**SITE PLAN REVIEW
PLANNER'S PUBLIC HEARING REPORT
Rocky Springs RV Park Site Plan Review
17094 Martin Pedro Road, Siloam Springs AR 72761**

RE: Rocky Springs RV Ranch - Comment Response Letter

ROCKY SPRINGS RV RANCH

TOPOGRAPHICAL SURVEY
ROCKY SPRINGS RV RANCH
17094 MARTIN PEDRO ROAD
SILOAM SPRINGS, ARKANSAS

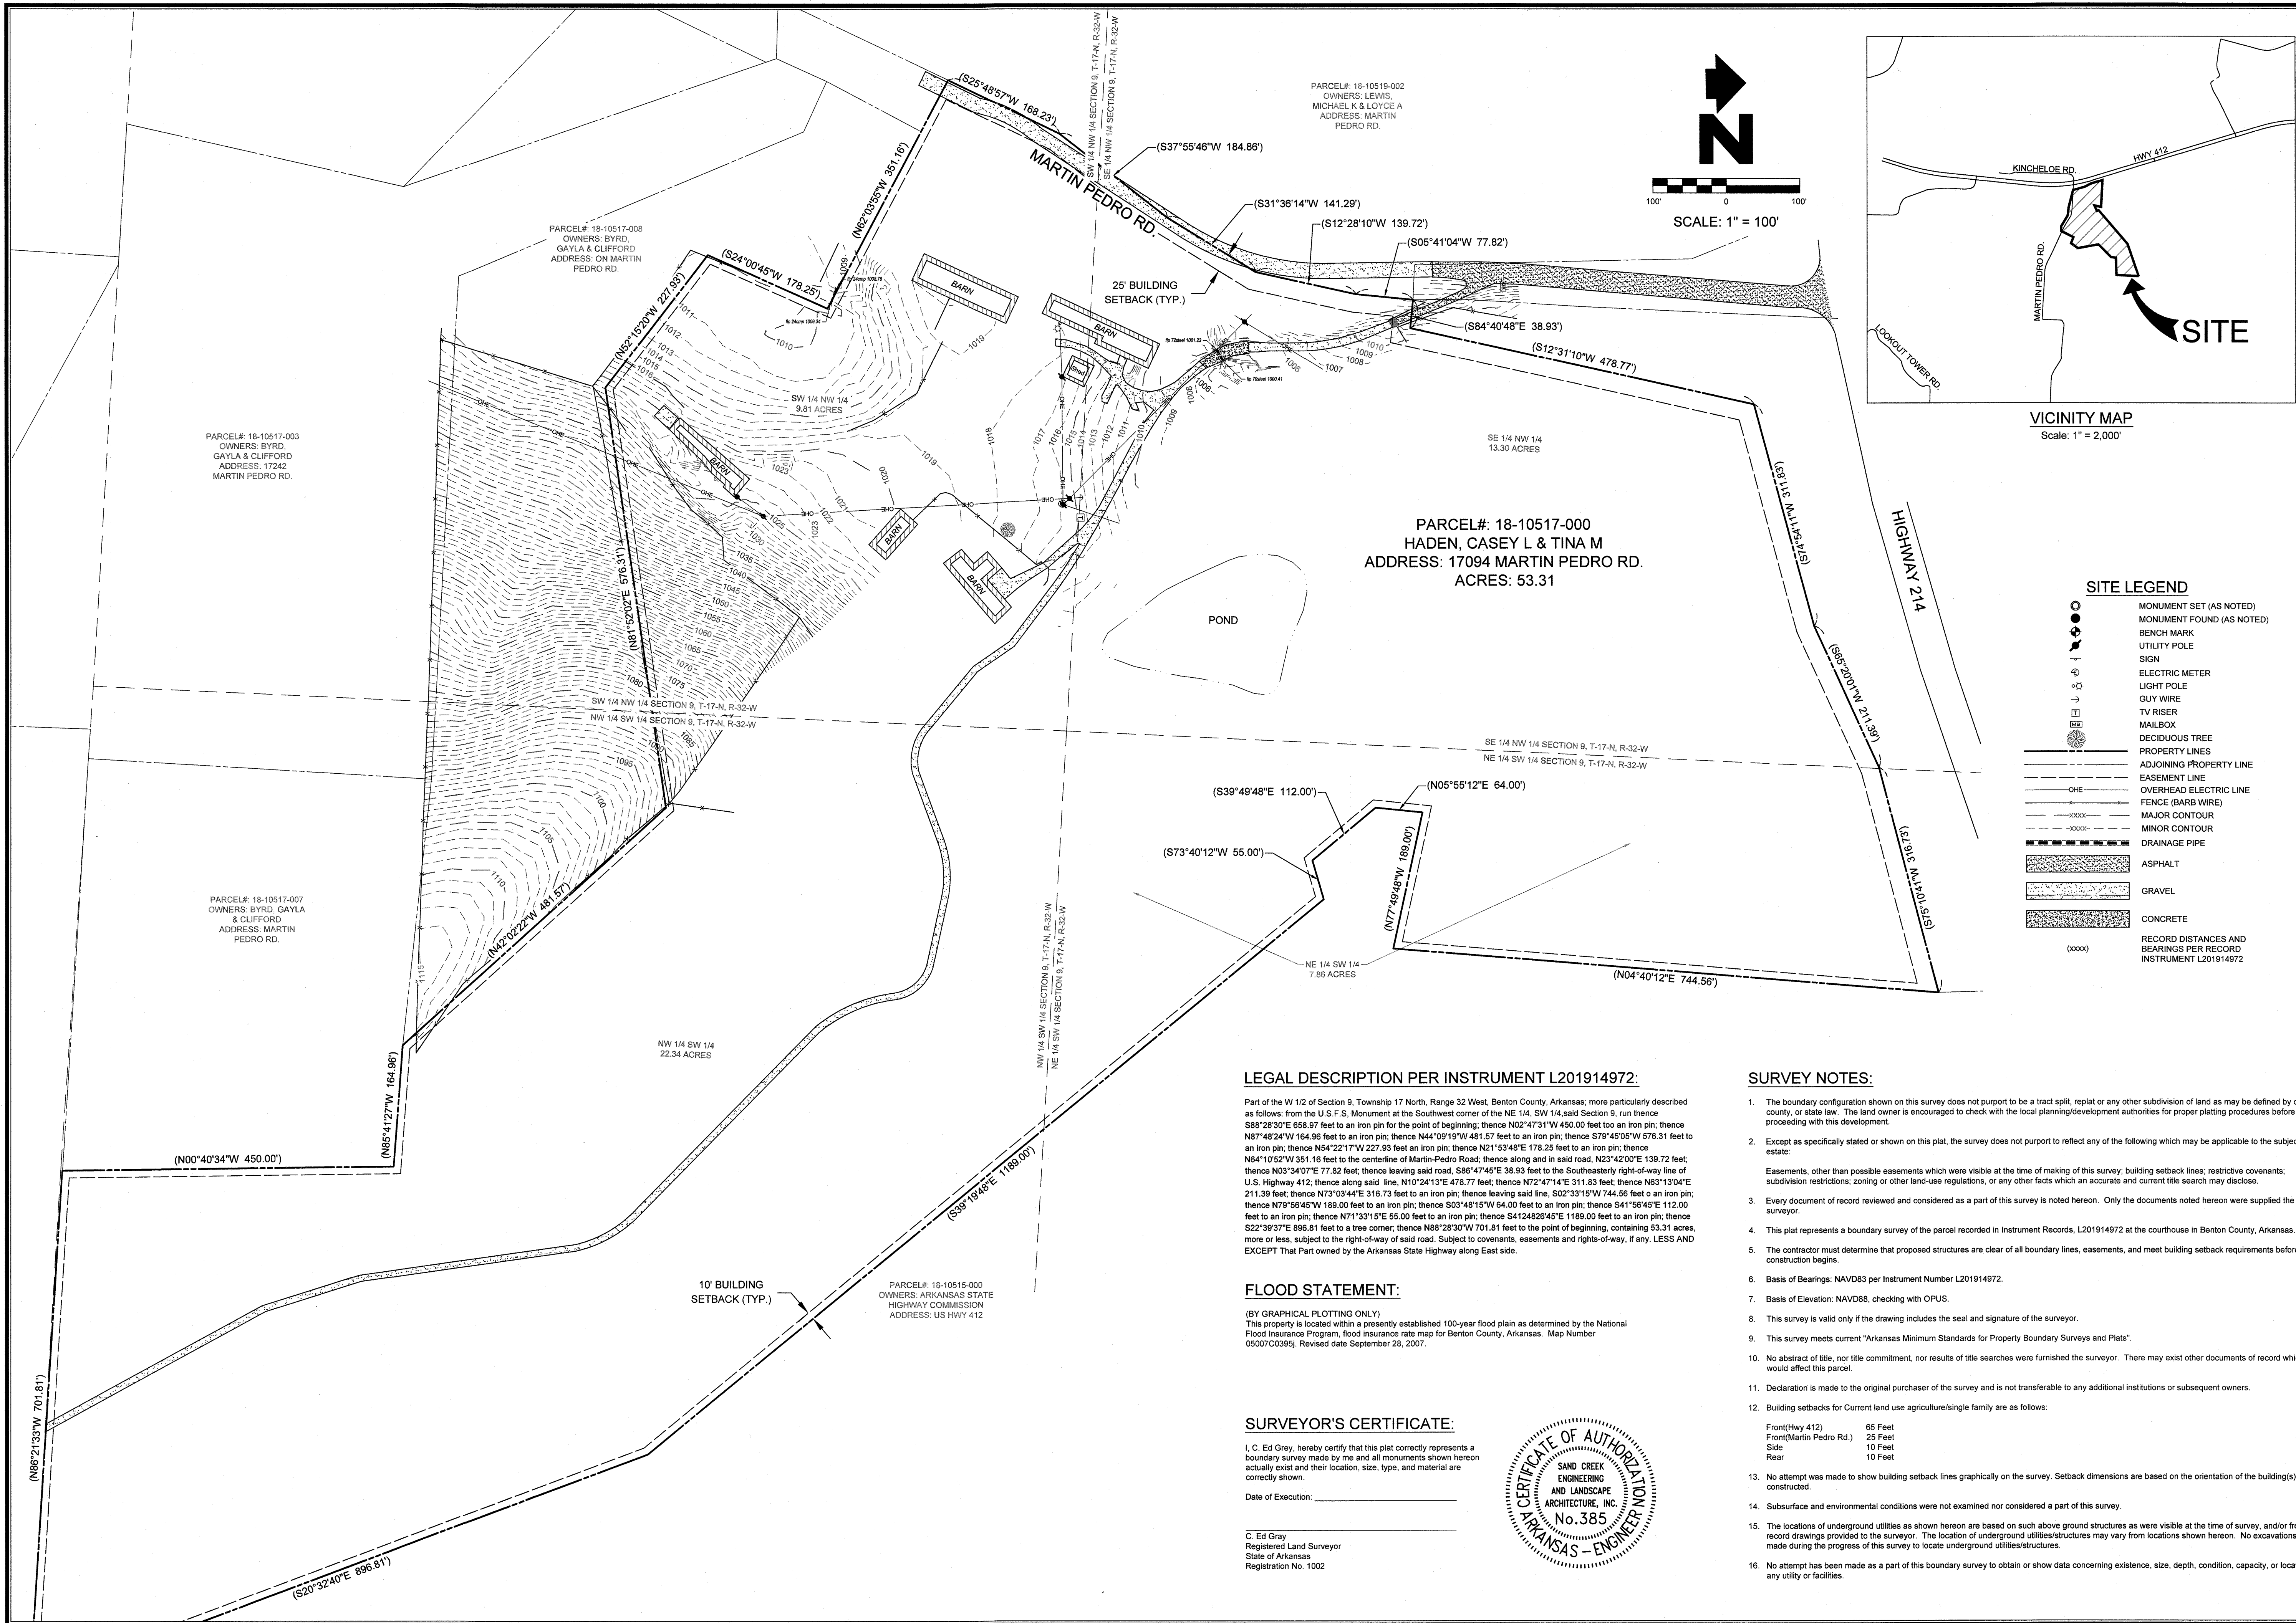
Comments: Revised site plans include sheet 2 detailing the legal property lines and County required setbacks.

1. Site Plan Revisions:
 - a. Include County Approval Block for Board Signatures
 - b. Show locations of outdoor lighting fixtures
 - i. Include the full cut off lighting note
 - c. Surveyor shall endorse sheet 2 of 6
 - d. Detail the location of dumpster and dumpster enclosure
2. Utility and Infrastructure:
 - a. ADH Plan Review approval shall be received for onsite septic and public water source prior to issuance of a decision letter

- i. **Survey shows all uses.**
 - l. Detail legal property lines and county required setbacks
 - i. **Survey shows all stated information.**
2. Stormwater management and Drainage:

SITE PLAN
ROCKY SPRINGS RV RANCH
LARGE SCALE DEVELOPMENT
BENTON COUNTY, ARKANSAS

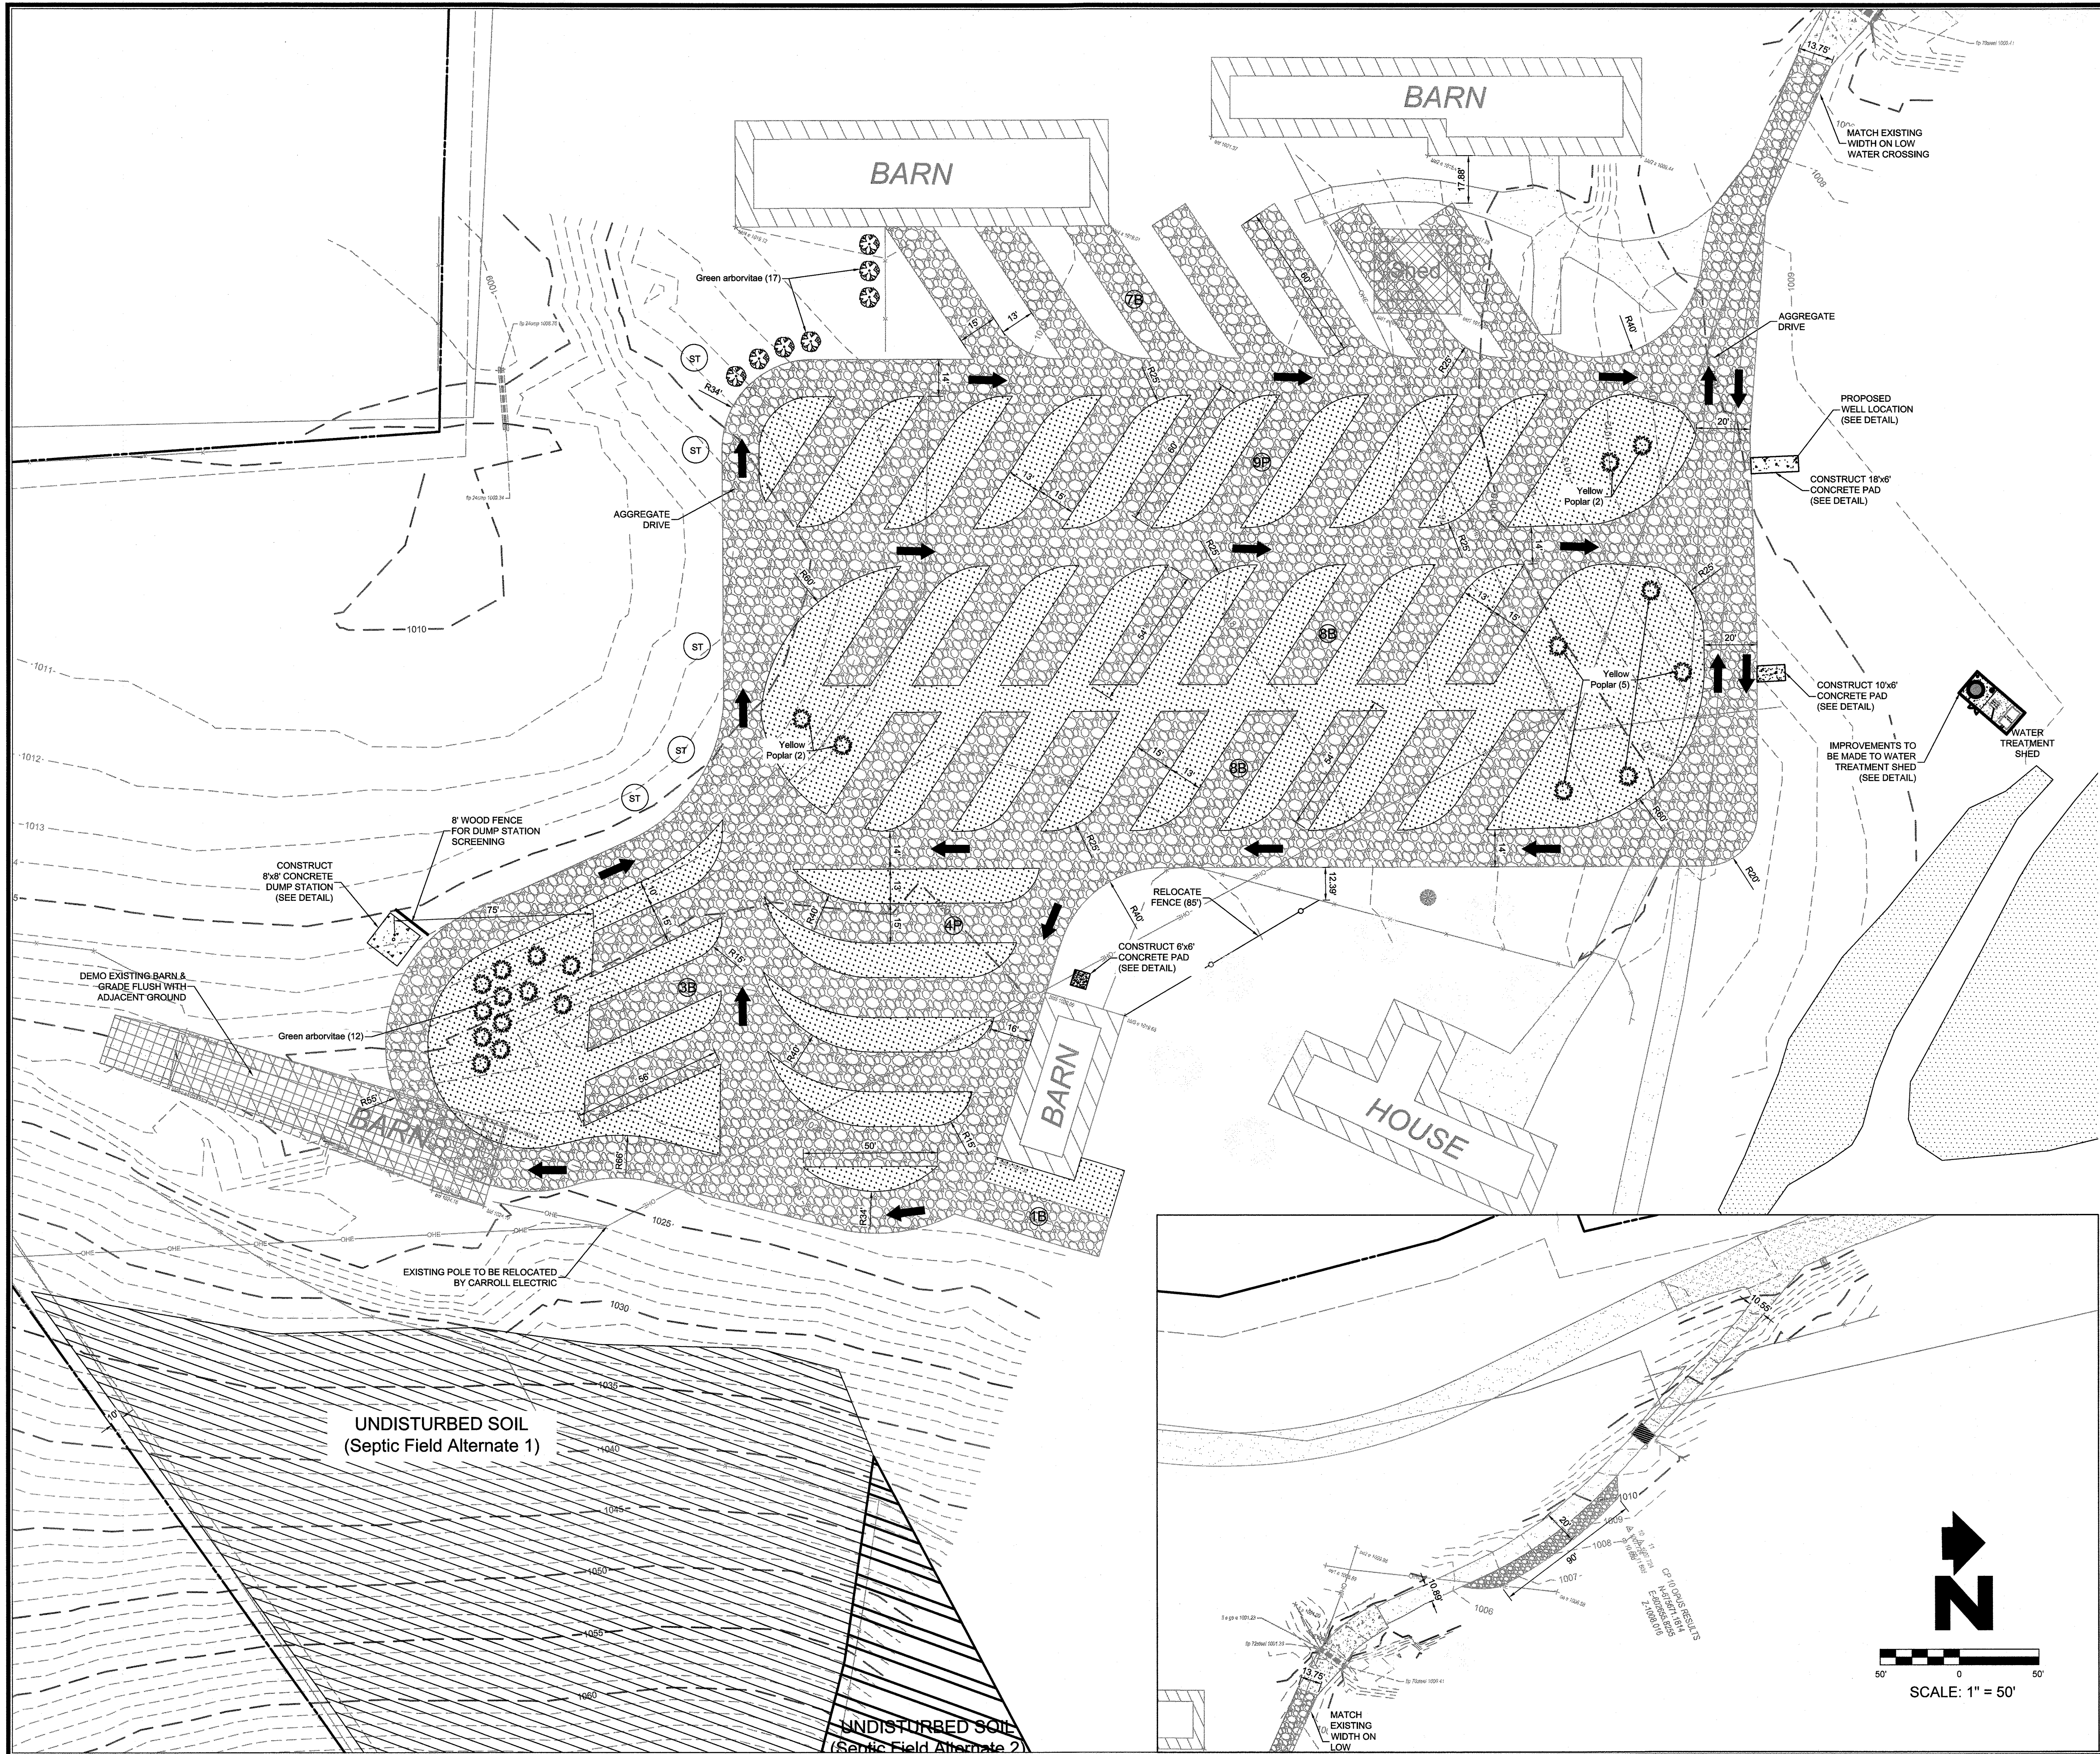
The Site Plan shall be revised to provide the locations of any existing or proposed outdoor lighting and a note that all outdoor lights will be 'full cut-off lighting in accordance with IESNA standards'.

The property owner submitted a service confirmation letter from Waste Management. **The project engineer shall revise site plans to include the dumpster location and the required enclosure.**

- a. Include case No. 19-070 on cover page
 - i. **Completed**
- b. Include County Approval Block for Board Signatures
 - i. **Completed**
- c. Revision Chart to accurately reflect revisions made throughout review process
 - i. **Completed**
- d. Show access drives widths from public right of way
 - i. **Shown on Site Plan**
- e. Show Traffic Circulation Arrows
 - i. **Completed**
- f. Detail RV spaces as pull through or back in
 - i. **Completed**
- g. Show restricted access gates, as applicable
 - i. **(Not applicable)**
- h. Show locations of outdoor lighting note
 - i. Include the Full Cut off Lighting note
 1. **Completed**

- i. Detail Type and Size of Proposed vegetative plantings
 - i. **Green Arborvitae (19), shown on site plan**
 - ii. **Yellow Poplar (9), shown on site plan**

WELL HEAD DETAIL N.T.S.

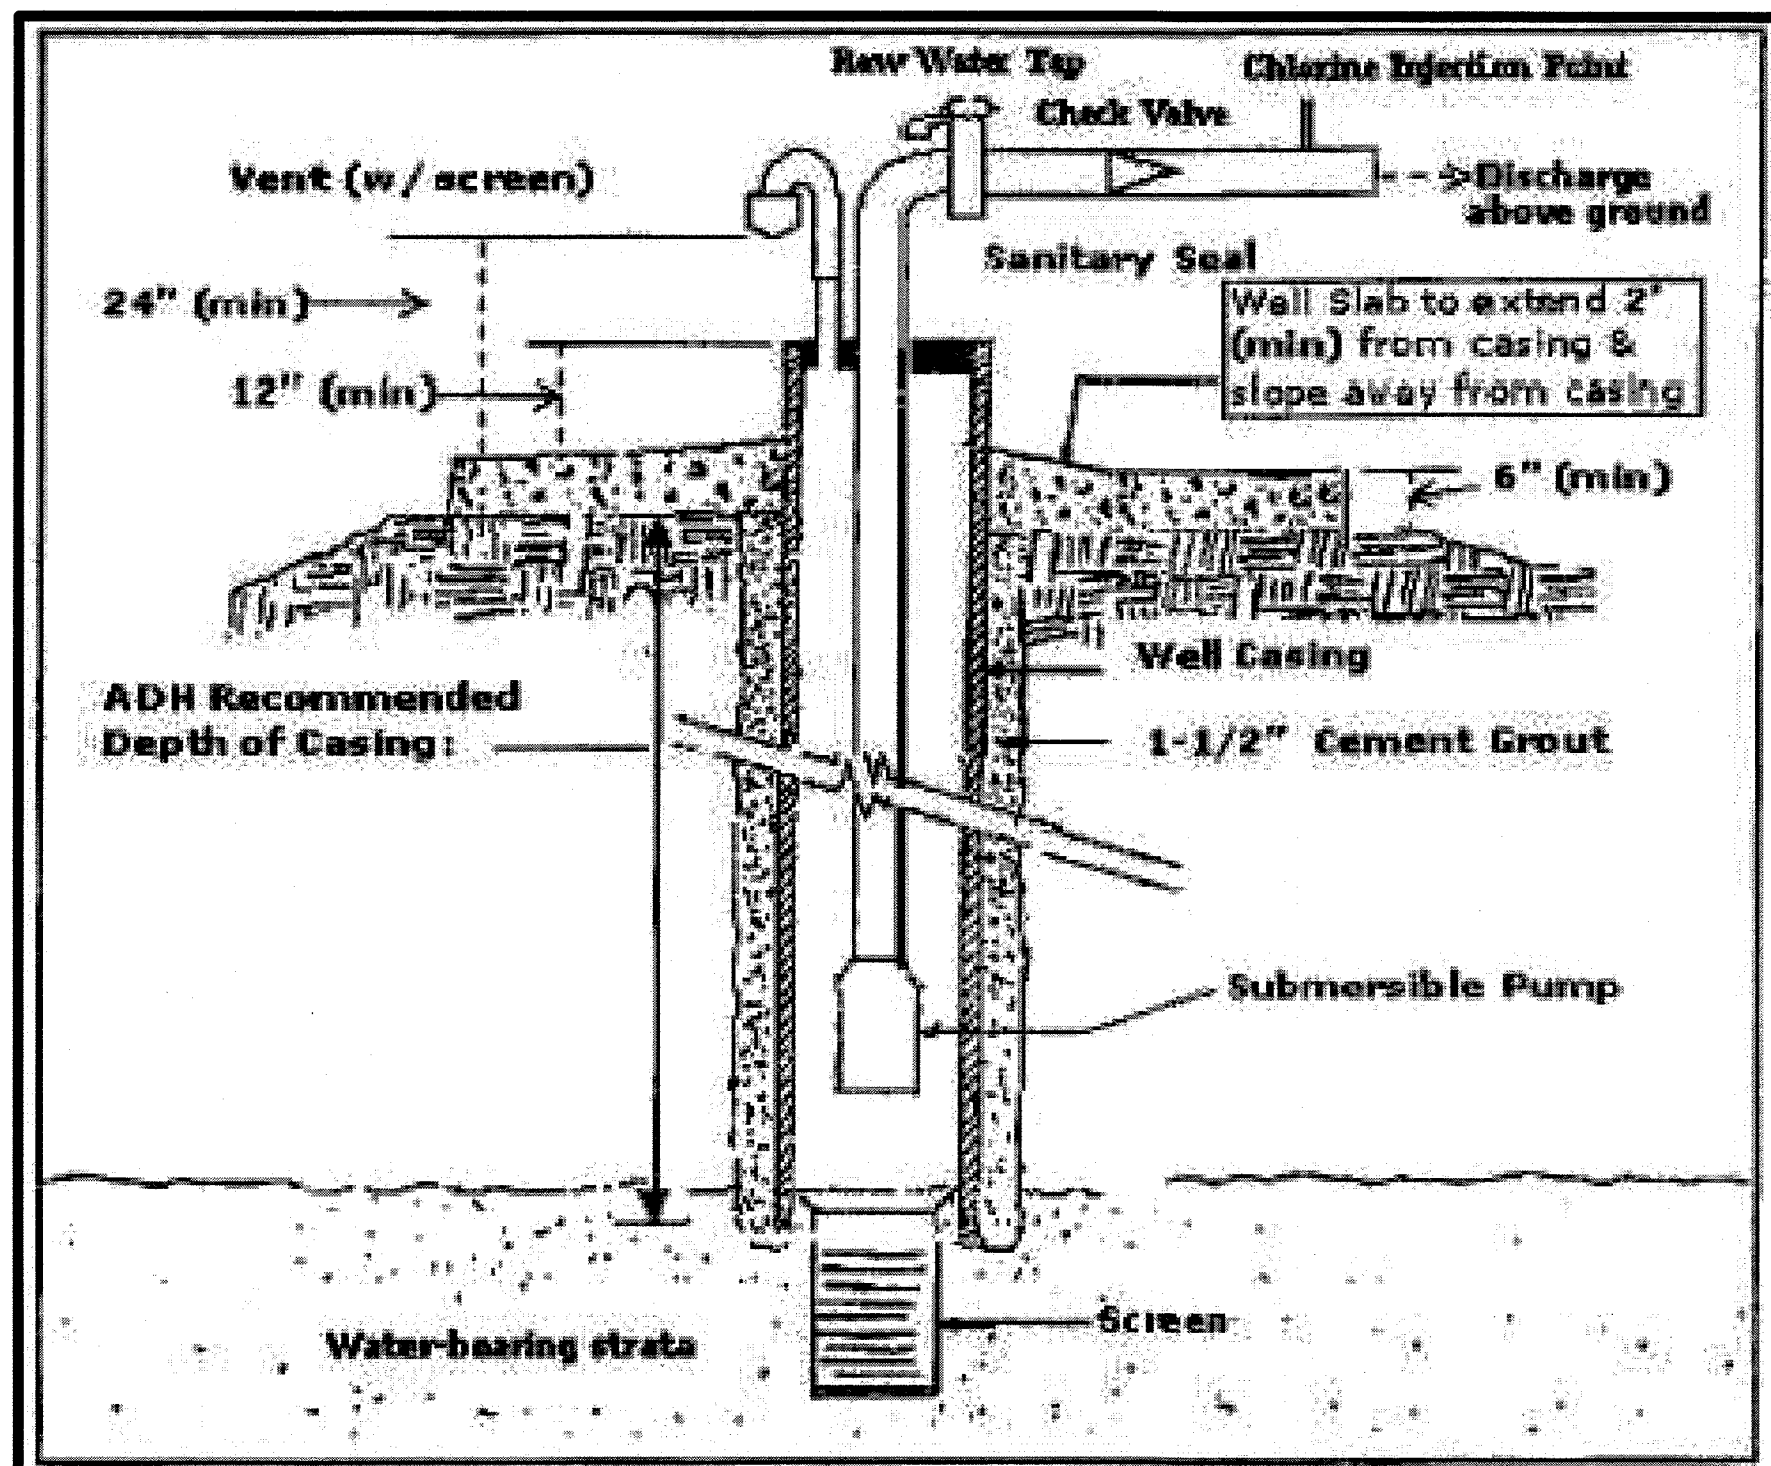
1. Well head construction details, disinfection system components, retention tank (if used), pressure tank(s) and a rough plumbing schematic are not shown. We need to review this portion of the treatment system in order to complete the plan review. Sample diagrams and instructions are in the "Guidelines" document.
2. The well is required to have 100' protected radius. Please adjust the proposed well location so that the existing pond is at least 100' away. (ref. *Rules and Regulations Pertaining to Semi-Public Water Systems* by the Arkansas Board of Health, Section VI, D.) (I know the well recommendation had GPS coordinates. Those are rough coordinates (actually, the spring coordinates that you gave me) that I gave to the geologist to locate the property. Sorry if that caused confusion.)
